AMENDMENT OF SOLICITATION/MODIFICATION OF CONTRACT			1. CONTRACT ID CODE	PAGE OF PAGES
2. AMENDMENT/MODIFICATION NO. 0003		3. EFFECTIVE DATE 12-May-2010	4. REQUISITION/PURCHASE REQ. NO. W5J9JE10R0063	1 5

14. DESCRIPTION OF AMENDMENT/MODIFICATION (Organized by UCF section headings, including solicitation/contract subject matter where feasible.) W5J9JE-10-R-0063 is amended to include a new bid schedule, a revised section 01010, and a revised Drawing C101 Site Plan. The date for receipt of offers remains May 23, 2010 at 3:00 p.m.				
Except as provided herein, all terms and conditions of the document referenced in Item 9A or 10A, as heretofore changed, remains unchanged and in full force and effect.				
15A. NAME AND TITLE OF SIGNER (Type or print)			16A. NAME AND TITLE OF CONTRACTING OFFICER (Type or print)	
			TEL: _____ EMAIL: _____	
15B. CONTRACTOR/OFFEROR	15C. DATE SIGNED	16B. UNITED STATES OF AMERICA		16C. DATE SIGNED
_____ (Signature of person authorized to sign)		BY _____ (Signature of Contracting Officer)		12-May-2010

AMENDMENT 0003

AFGHAN NATIONAL ARMY
25 BUNKERS
POL-E-MARJA, AFGHANISTAN

REFERENCE
C-101
SHEET 1 OF 1

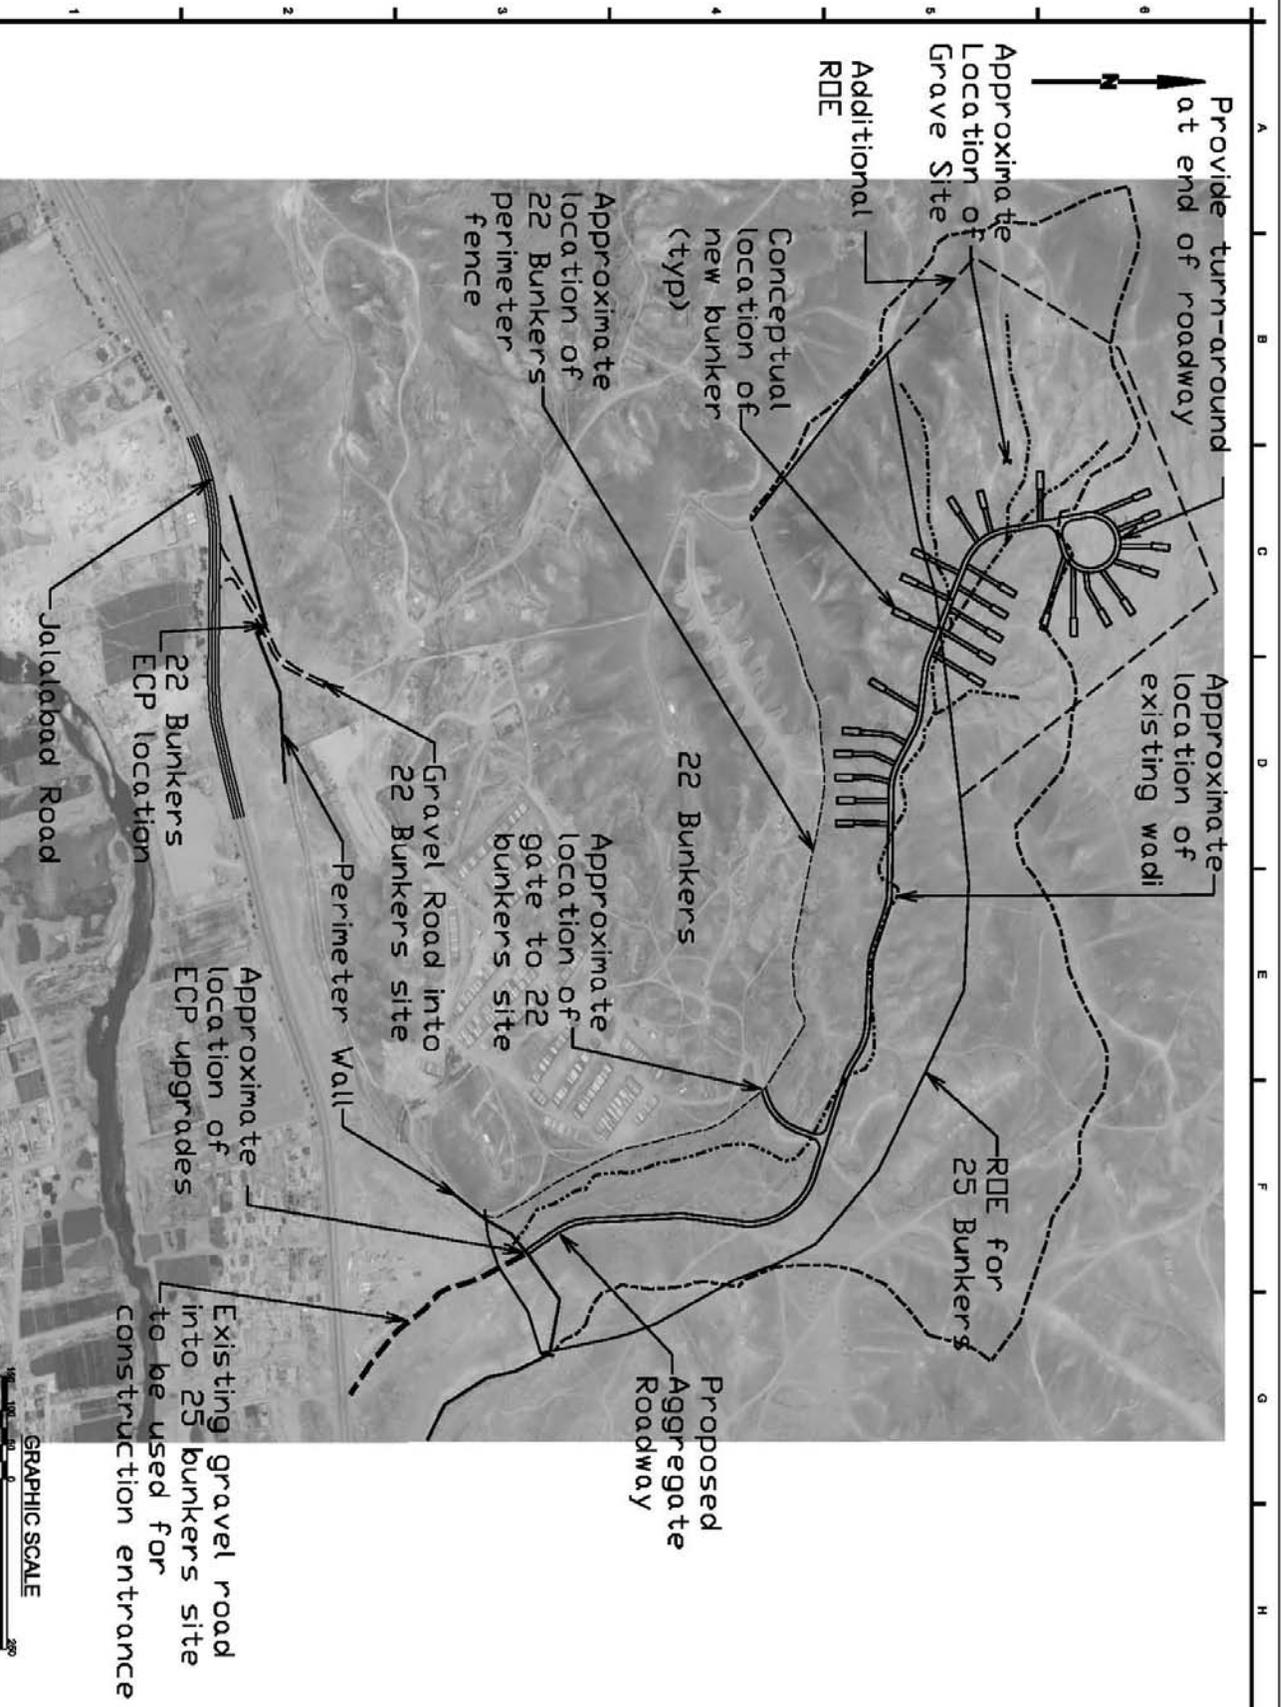
5. Delete Drawing C101 Site Plan and replace with the revised Drawing C101 that accompanies this amendment.
